<b>Product/Process Change Notice (PCN)</b>	
<input checked="" type="checkbox"/> Major Change <input type="checkbox"/> Minor Change	
<b>PCN Number:</b> PCN_UtWPCC-Tx_20250228  <b>Affected Series:</b> Wx-UtWPCC-Tx  <b>Affected Part Number:</b> 760308111  <b>PCN Date:</b> 2024-11-28 (YYYY-MM-DD) <b>Effective Date:</b> 2025-02-28 (YYYY-MM-DD)	<b>Change Category:</b> <input type="checkbox"/> Equipment/Location <input type="checkbox"/> General Data <input type="checkbox"/> Material <input type="checkbox"/> Process <input checked="" type="checkbox"/> Product Design <input type="checkbox"/> Shipping/Packaging <input type="checkbox"/> Supplier <input type="checkbox"/> Software
<b>Contact:</b> Product Management <b>Phone:</b> +49 (0) 7942 - 945 5001 <b>Fax:</b> +49 (0) 7942 - 945 5179 <b>E-Mail:</b> pcn.eisos@we-online.com	<b>Datasheet Change:</b> <input checked="" type="checkbox"/> Yes <input type="checkbox"/> No  <b>Attachment:</b> <input type="checkbox"/> Yes <input checked="" type="checkbox"/> No

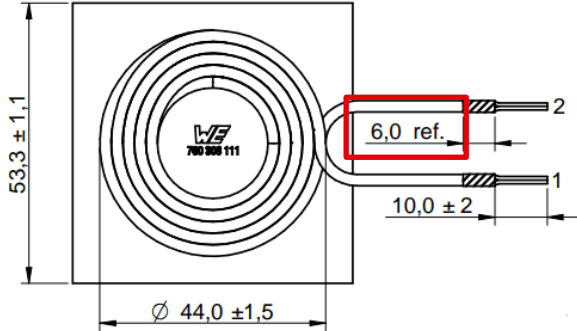
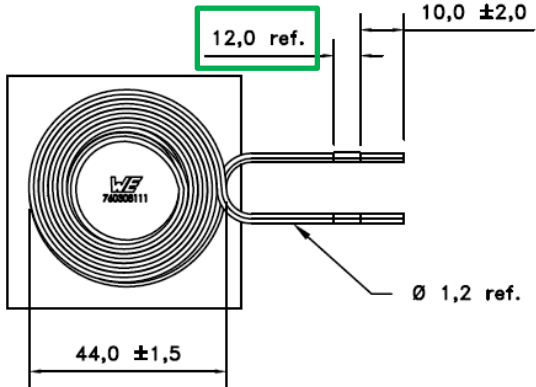
<b>DESCRIPTION OF CHANGE:</b> <p>In order to enhance the product reliability, Würth Elektronik will increase the length of the heat shrink tubing on 760308111.</p> <p>There will be no change in fit, function, or quality of the product.</p> <p>The new revision of the affected part numbers will be sent out after the previous revision is out of stock (according to FIFO - first-in, first-out).</p>	
<b>DETAILS OF CHANGE:</b>	
<b>Before Change</b>	<b>After Change</b>
